PLANNING

Rev	Description	Date	By	Client	Scale	Drawn by	Checked by	Rev
P5	General update - revision clouds added to indicate changes	10.03.10		Queen's Grove Residents	1:100 @ A3	ZF		
P6	Issue to DP9	24.03.10		40 Queen's Grove, NW8	October 2007	RK		
P2	Issued for Information	10.06.09						
P3	General update - issued for information	10.02.10						
P4	Updates client meeting 19.02.10 as minutes. Issued for info.	23.02.10	DL					
				Eric Parry Architects	Proposed Roof Plan			
				28 - 42 Banner Street London EC1Y 8QE Tel 020 7608 9600 Fax 020 7608 9601 www.ericparryarchitects.co.uk	EPA QGR 01 103			
					P6

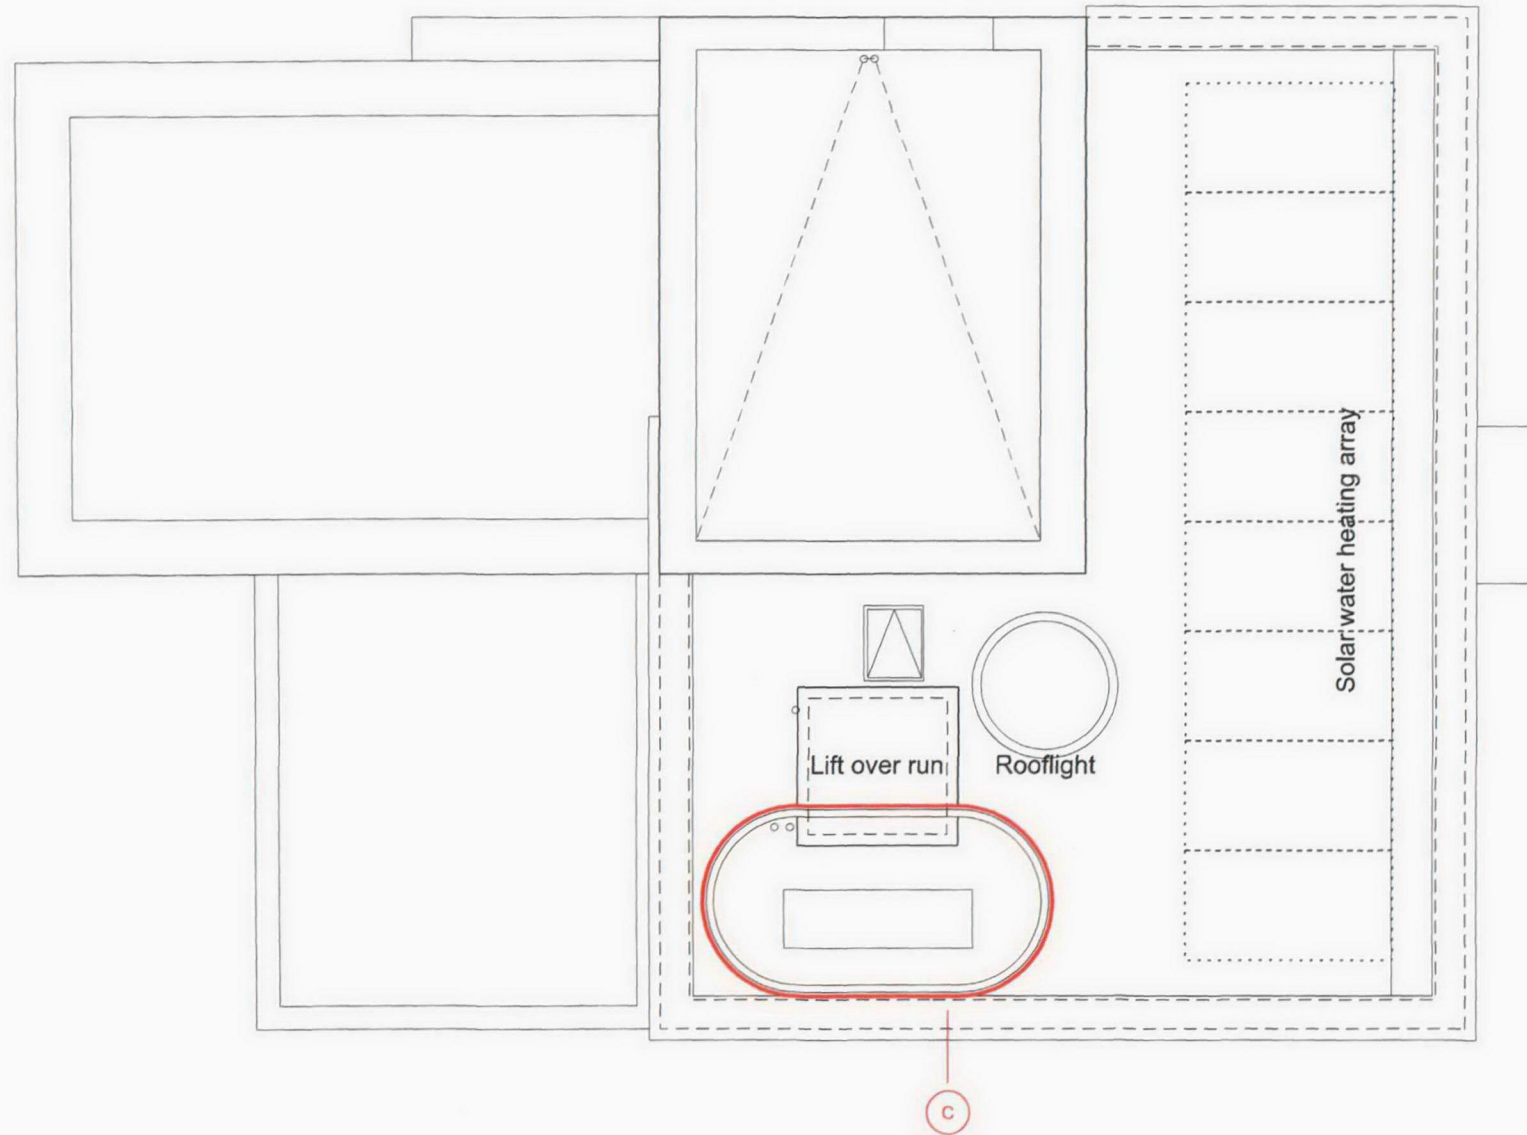
- C Introduction of a roof top air source heating and cooling in lieu of the combined ground source and heat rejection units at application. The form of the louvred enclosure is curved so it diminishes in street and garden views and about the same height as the chimneys of the neighbouring villas.

Note: Internal partitions have amended to suit revised layouts
